CIS Building – Manchester

DAS ADDENDUM | 24 MARCH 2020
10246-SHP-RP-DAS ADDENDUM | REV 01

Introduction

The purpose of this document is to provide additional information to address the specific comments and points of clarification raised by internal Manchester City Council consultees during the determination period. The document does not change any of the submitted documents or the information within them.

Existing Mass

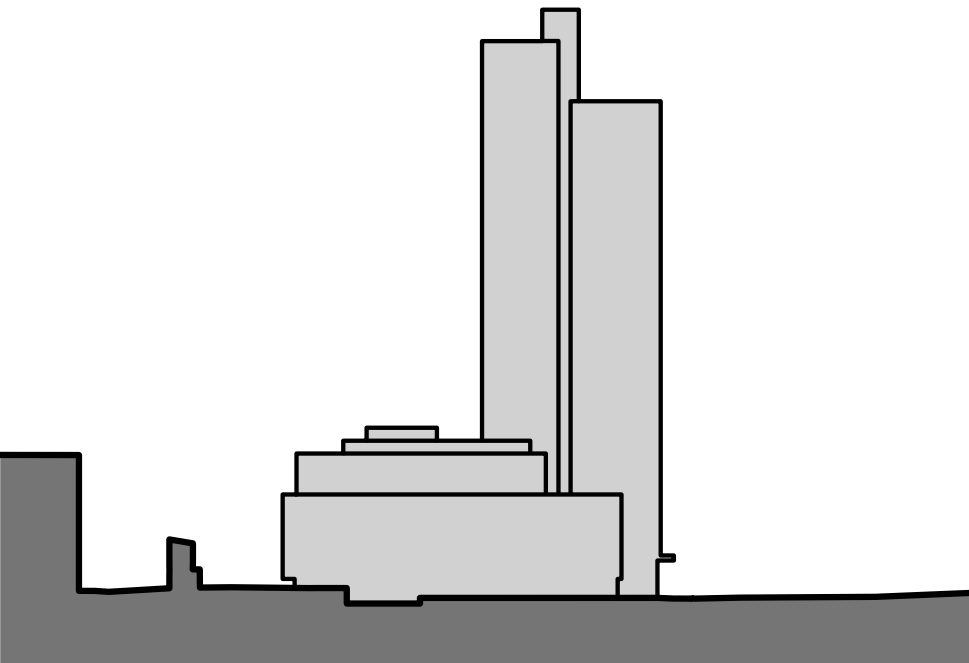
“The podium-roof plant room was designed to be a relatively anonymous feature on an enclosed elevation, which contrasted with the building’s glazed elevations and the visual movement afforded by the aluminium-alloy mullions. The clearance of the former warehouses and the development of the lower-lying bus-station exposed the rear elevation of the CIS Building and emphasises the solidity of the plant-room as an intrusive roof-top feature which detracts from the view of this ancillary elevation. Therefore, although the plant-room is an existing feature, its exposure evidently results in a degree of compromise to the contemporary views of the CIS Building from particular views along Dantzic Street”

Relocation of the Recreation Hall at L7 (Presented in DAS as Option 2)

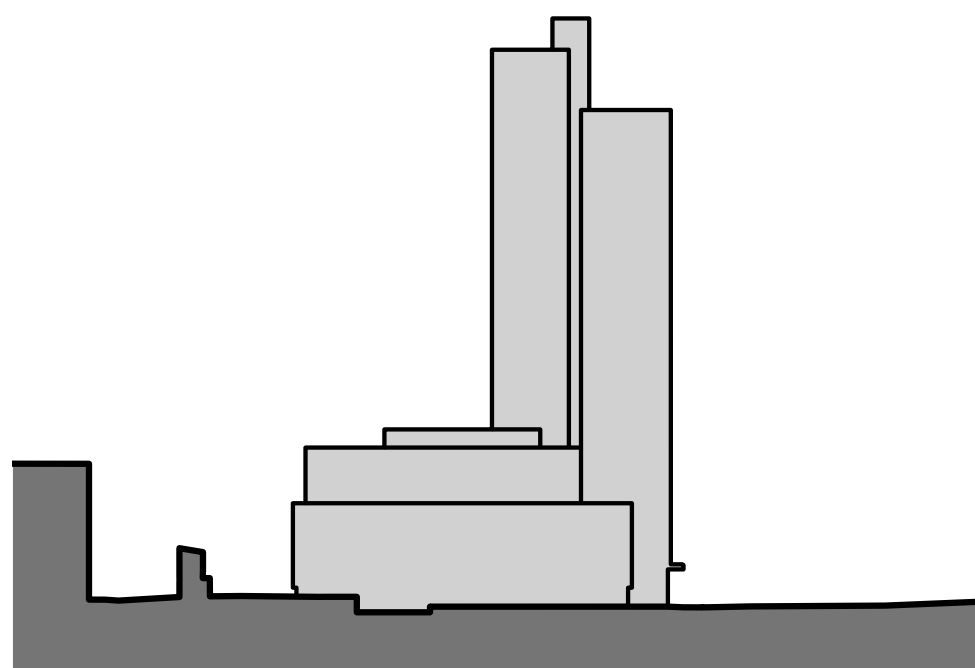
“The potential option to create a two-storey volume, sat beneath two further set back single storey roof-top volumes would increase the visual prominence of the podium extension and, thereby, exacerbate the apparent visual compromise of the rear, podium-extension to the CIS Building. The simple, larger volume would extend across the podium and the visually embrace both service tower and the main office-block, resulting in an undue focus on this ancillary elevation and would result in a minor adverse visual impact”

Three storey Office extrusion with offset Plant

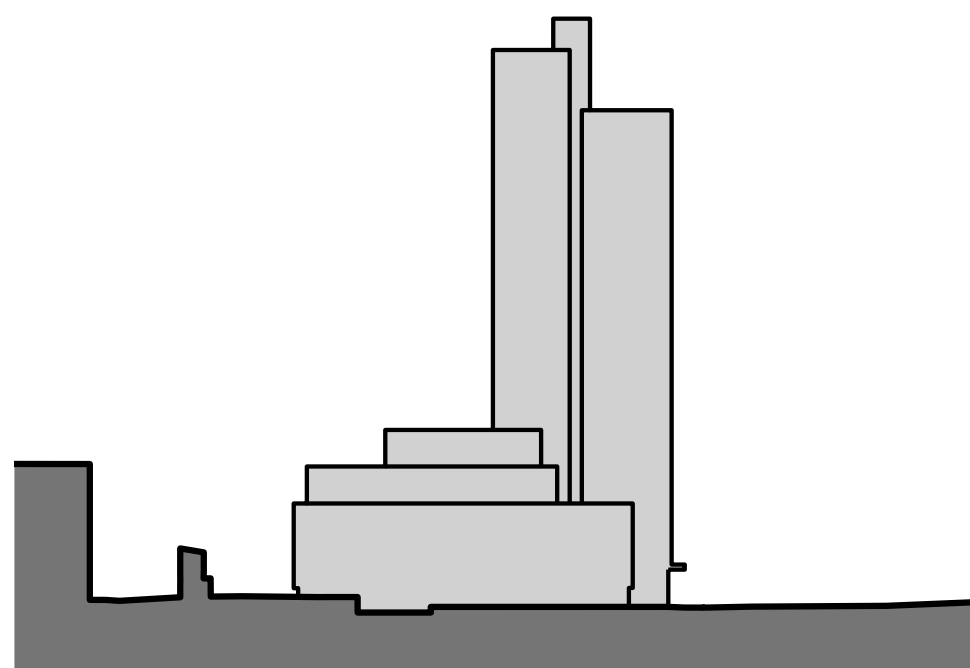
"The potential option to create a three-storey roof-top volume with a set back single storey plant volume, was considered to increase the visual prominence of the podium extension and, thereby, exacerbate the apparent visual compromise of the rear, podium-extension to the CIS Building. The simple volume extends across the podium and has an increased impact on both the service tower and the main office-block, resulting in an undue focus on this ancillary elevation. This would result in moderate adverse visual impact"

Relocate of the Recreation Hall at B1 (Two tiers, presented in DAS as Option 3)

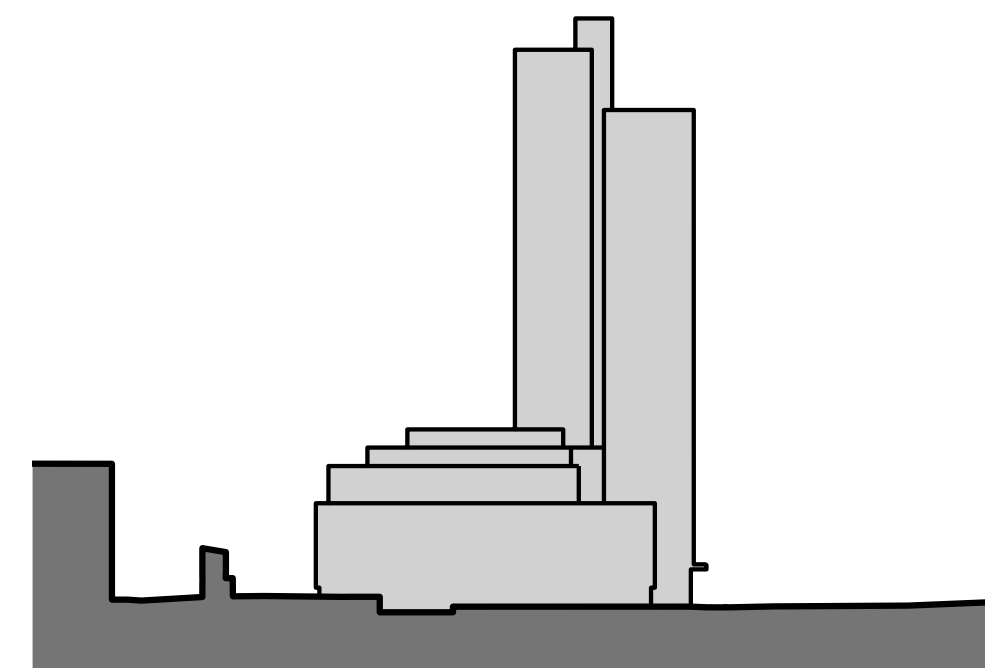
"The potential option to create a stepped four-storey roof-top volume, while reducing the impact on the main tower, was considered to fail to address the proportions of the podium's elevations and the horizontal expression of the floors from this rear view. The increased the visual prominence of the podium extension would, thereby, exacerbate the minor degree of visual compromise of the rear of the CIS Building. This would result in minor adverse visual impact"

Restore and relocate Barry Daniels' artwork to B1 (Three tiers, presented as Planning Scheme)

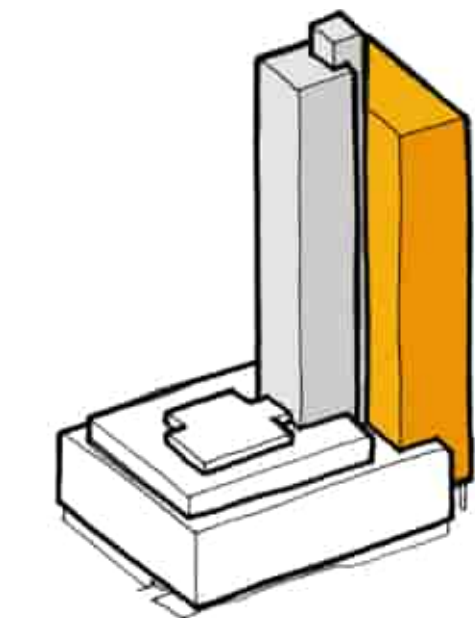
"The proposed three-storey extension, with a single storey plant volume above it, is clearly interpreted as a new addition to the podium (and rear of the building) and remains appropriately deferential to the design focus, scale and mass of both service and main tower by breaking-up the mass into stepped components. The materiality and stepped form of the addition integrates the roof-top addition into the rear elevation to avoid an undue focus on this addition to the building's components. Therefore, despite its scale and mass, the proposed development from this perspective would not diminish the intrinsic aesthetic values and special interest of the CIS Building from this ancillary, rear view, resulting in a negligible adverse heritage impact"

Plan illustrating area of existing granite floor within proposed enlarged entrance hall

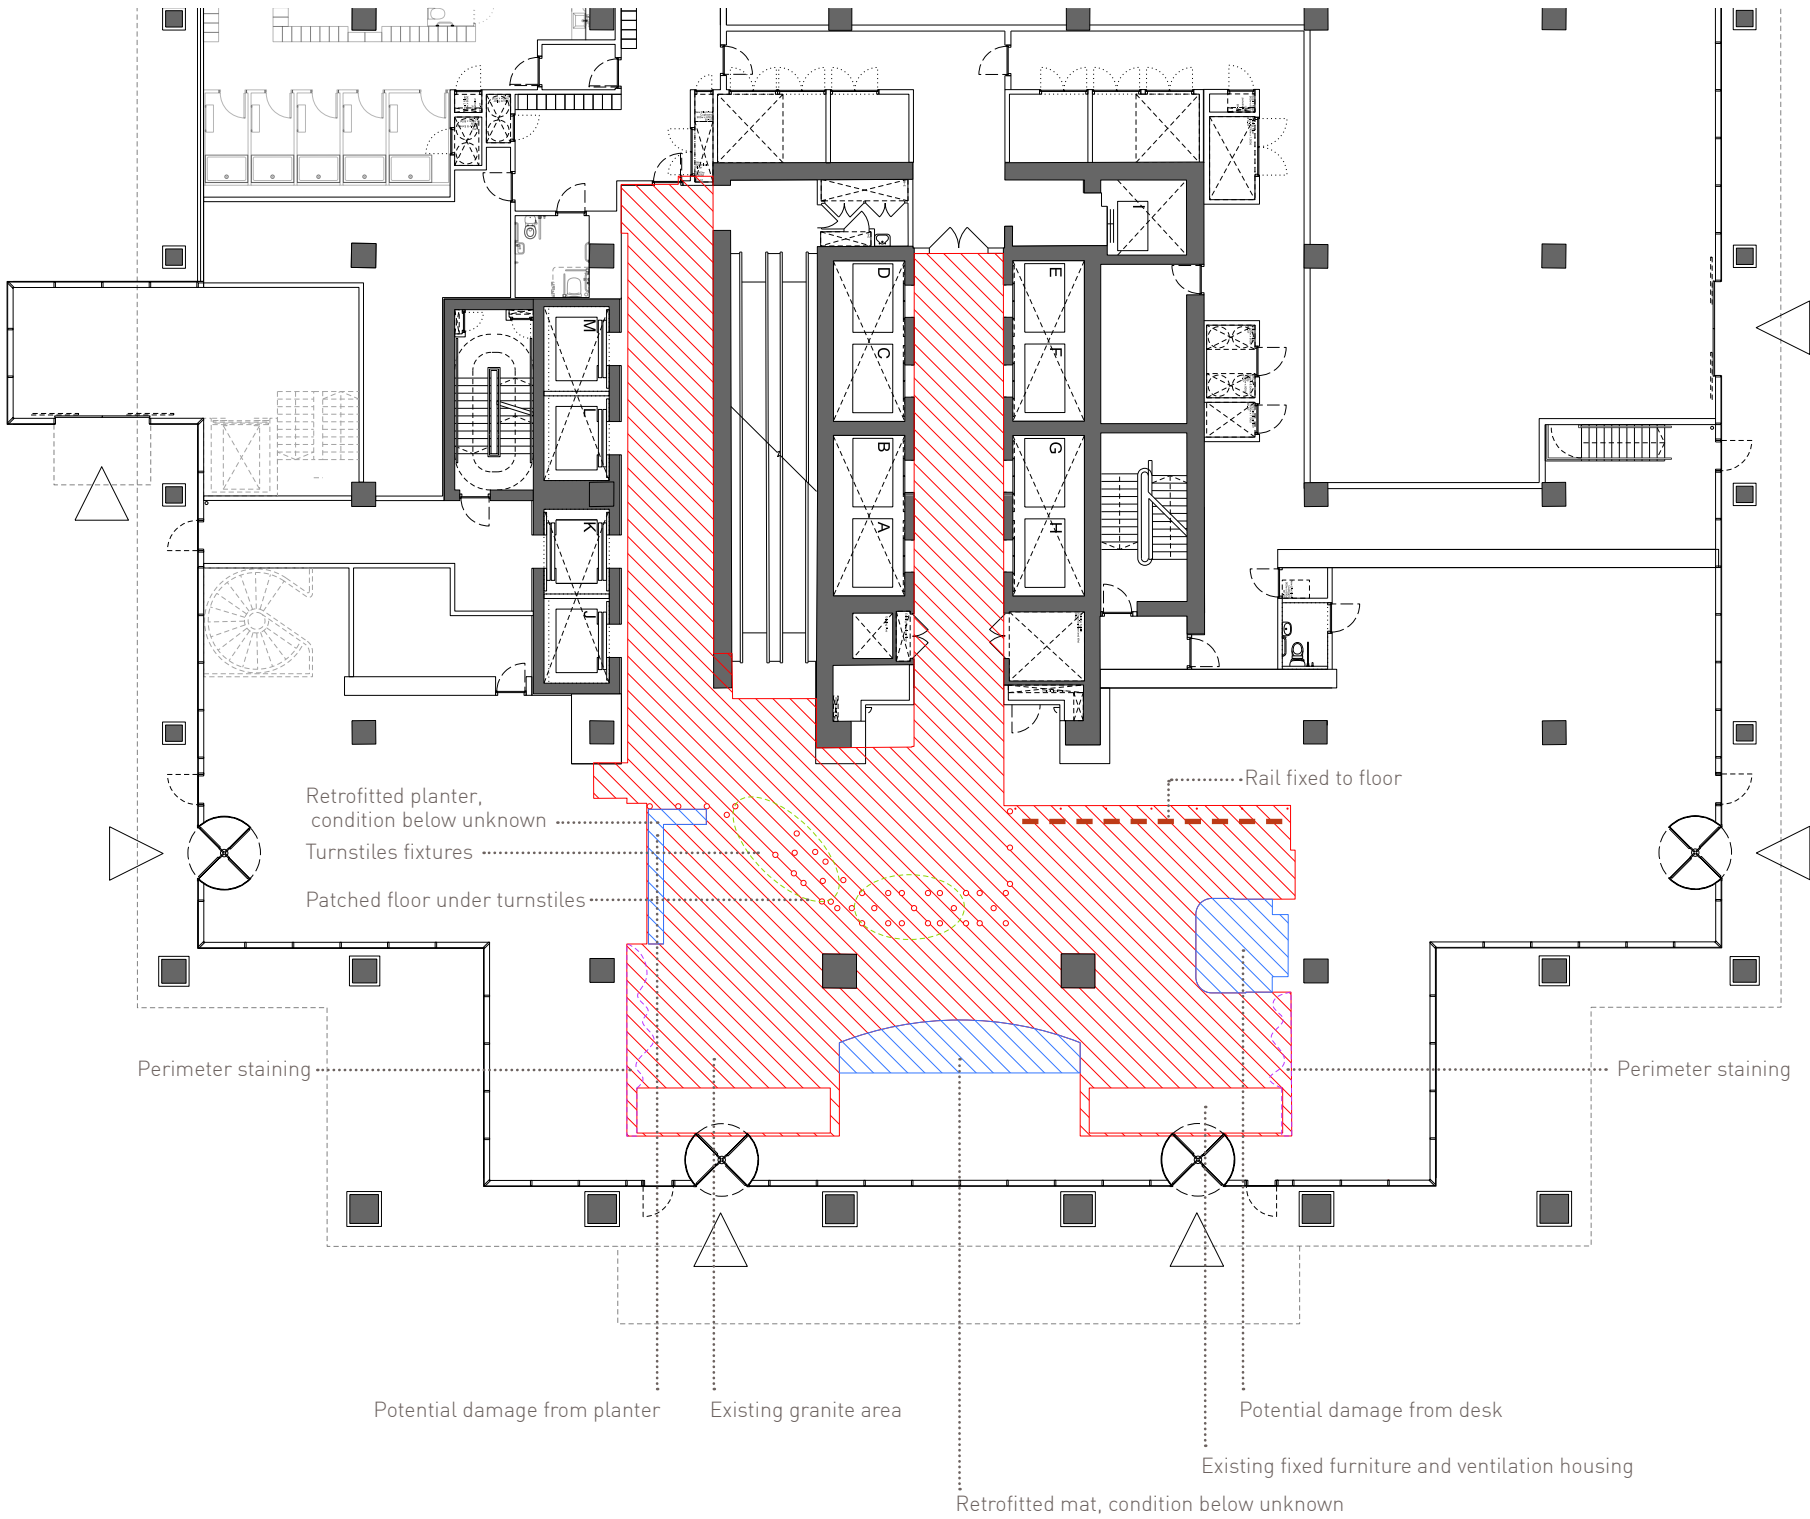
- › *“The ground-floor entrance hall was recorded as being the most disappointing space on the building on its opening and, although a highly-significant space, has also been considerably adapted since 1962 in a series of adaptations. The alteration works resulted in the original fabric and design being compromised by alterations to the: ceiling, floors, lighting, wall cladding, cladding of the internal columns and replacement furniture. The Cornish Granite floor is the most authentically surviving single element, although variations in the material created a random patchwork effect which has been exacerbated by subsequent alterations, including the installation of the existing security control barriers.”*

- › *“The design objective is to recover the character of the entrance as the focal point of the building. The enhanced accessibility of the enlarged entrance provides the opportunity to recover the coherence of the floor-covering as a unifying feature connecting the new Dantzic entrance and the new lifts into a coherent whole. The beneficial impact resulting from the re-creation of a coherent and appropriately accessible interior entrance space will far outweigh the loss of the compromised floor-covering.”*

- › New flooring is proposed throughout the enlarged entrance hall which would require the removal of the existing granite floor finish. This is to unify the enhanced and enlarged entrance hall.

- › It would be not be possible to match the existing granite floor with the new surrounding floor finish. It is important the enlarged reception hall appears as a unified space and mismatched materials would not achieve this. In addition, the existing granite floor is already very patched due to the many alterations to the reception hall over the years:

The adjacent drawings illustrate the existing marble wall finishes that are to be removed, in addition to those on walls that are proposed to be demolished

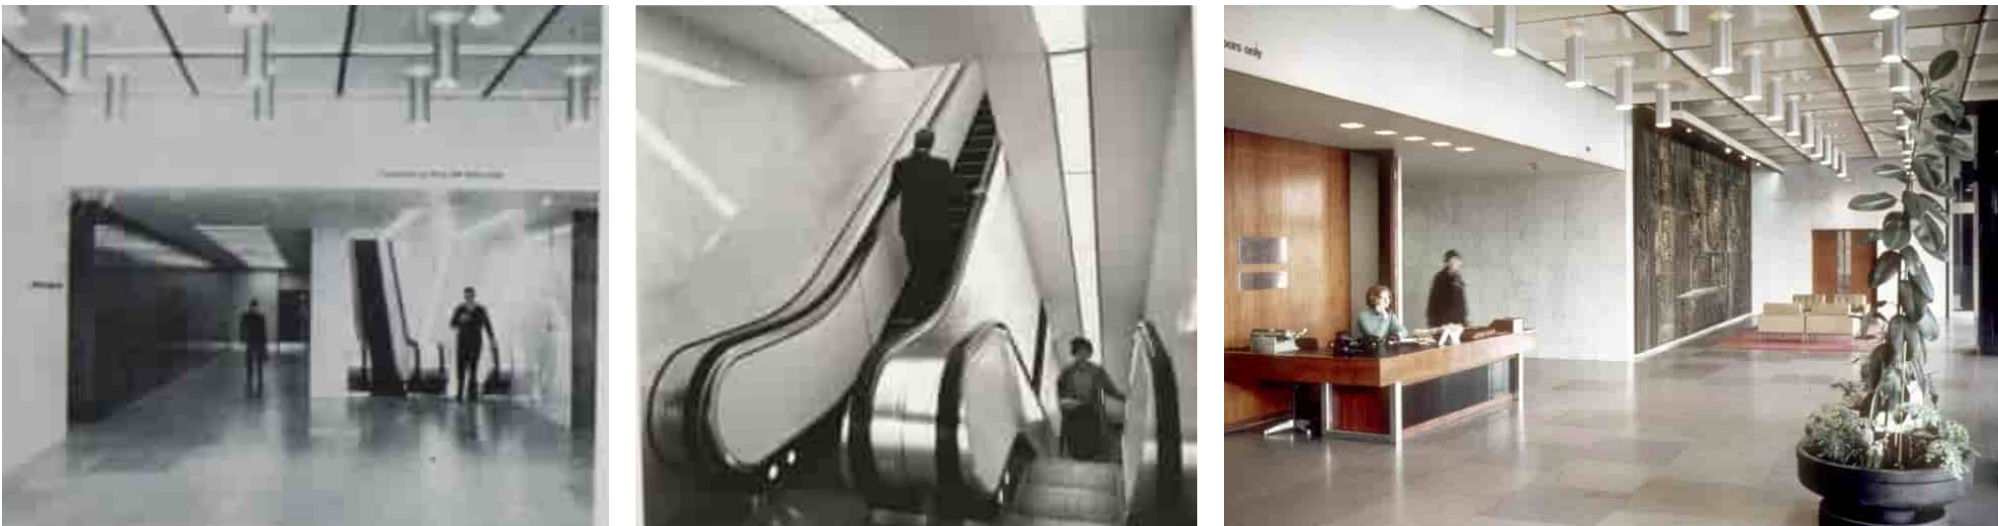
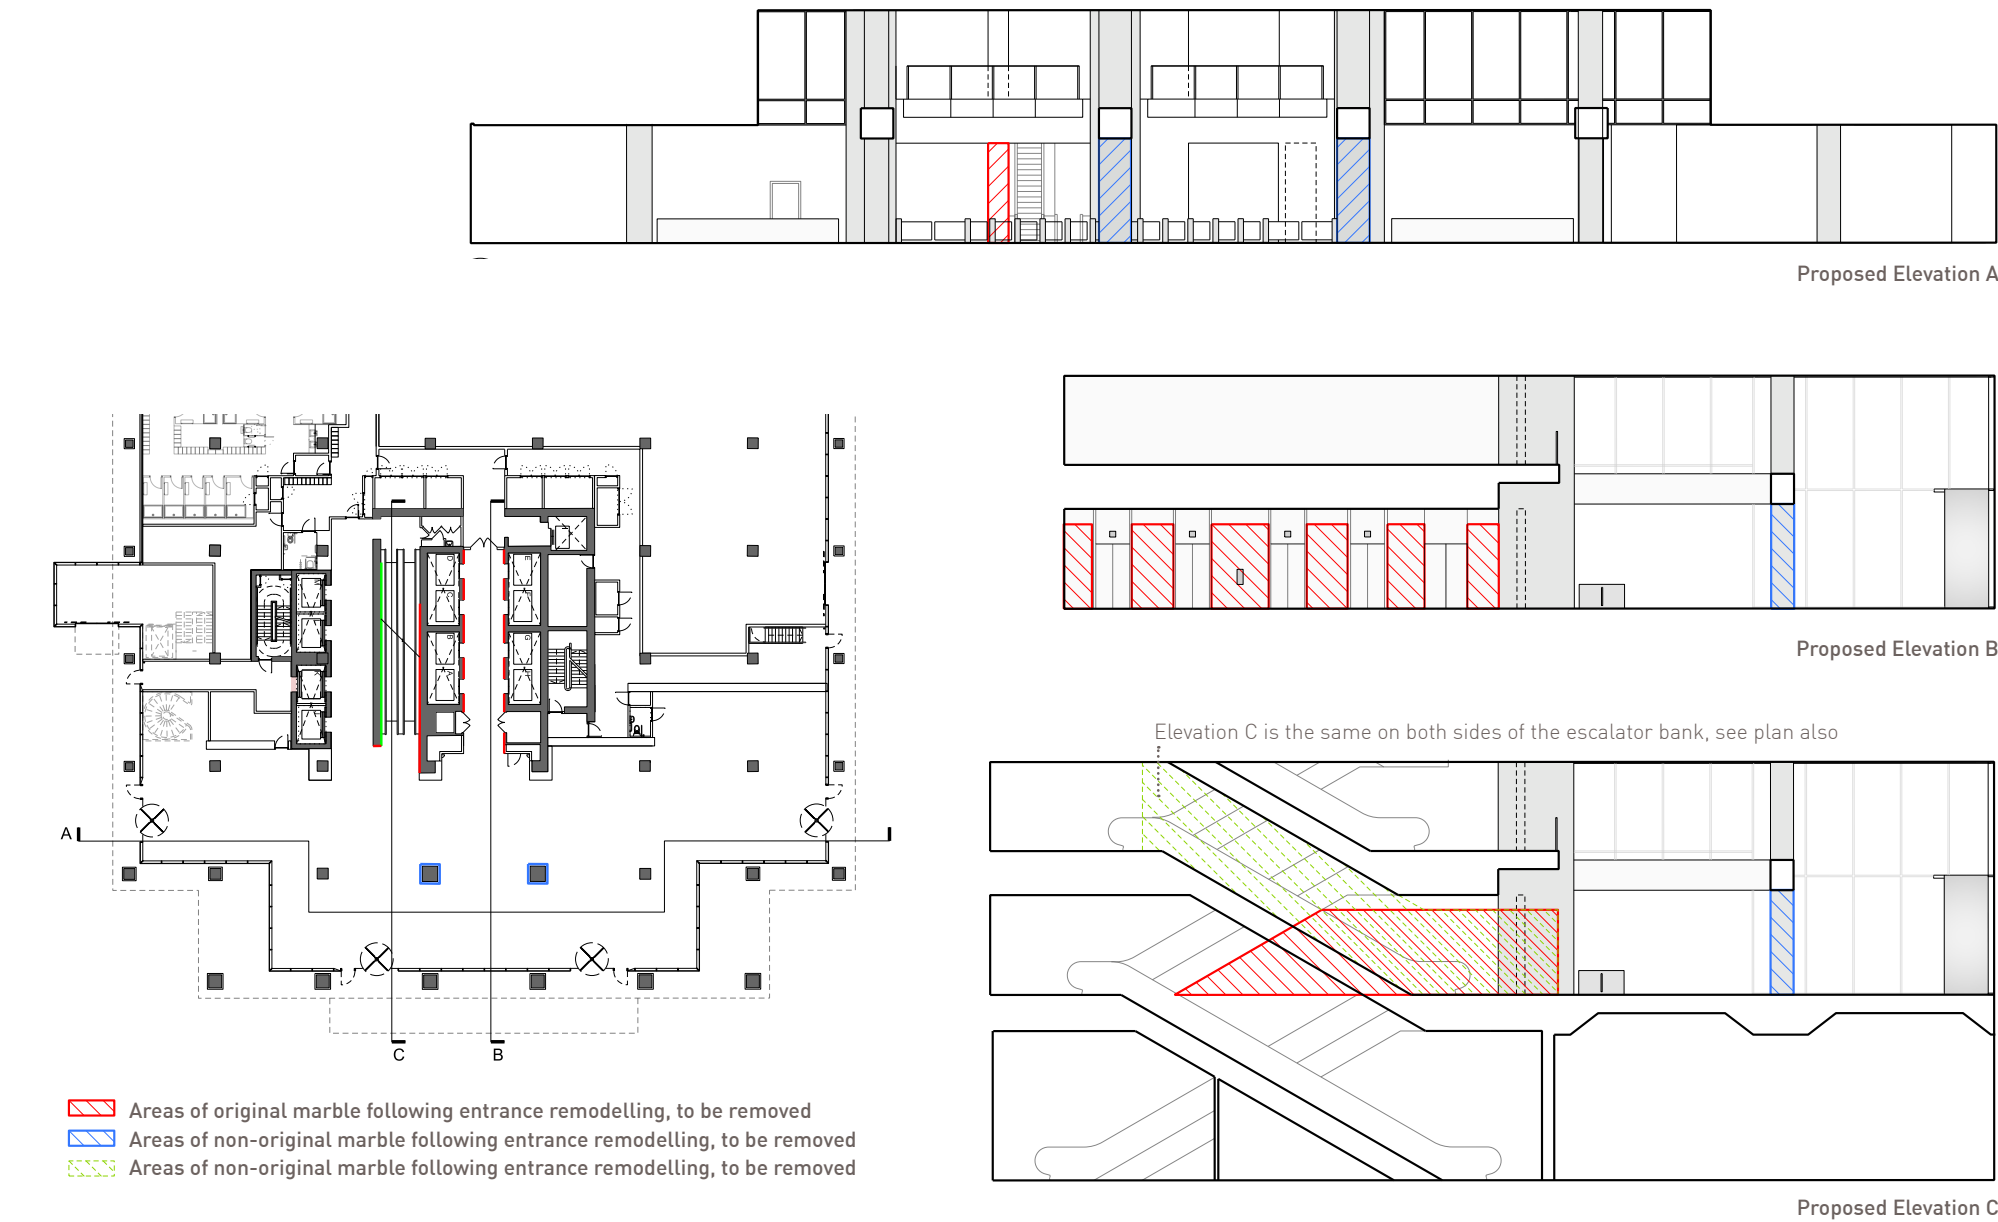
- > *“The design objective is to retain the key features of the entrance which includes the escalators. The wall materials were intended to be read as high-quality but neutral backcloth to the space and the William Mitchell artwork. The interior elevations (along with the ceilings) were altered following a series of refurbishments, including the cladding to the escalator enclosures. The enhanced accessibility of the enlarged entrance also provides the opportunity to recover the coherence of the space. The beneficial impact resulting from the proposed accessible and coherent interior entrance space will far outweigh the minor change to the wall coverings.”*

- > It is proposed to replace all the marble with a high, quality material such as large format porcelain tiles to avoid mismatched materials and to provide coherence to entire, enlarged reception hall.
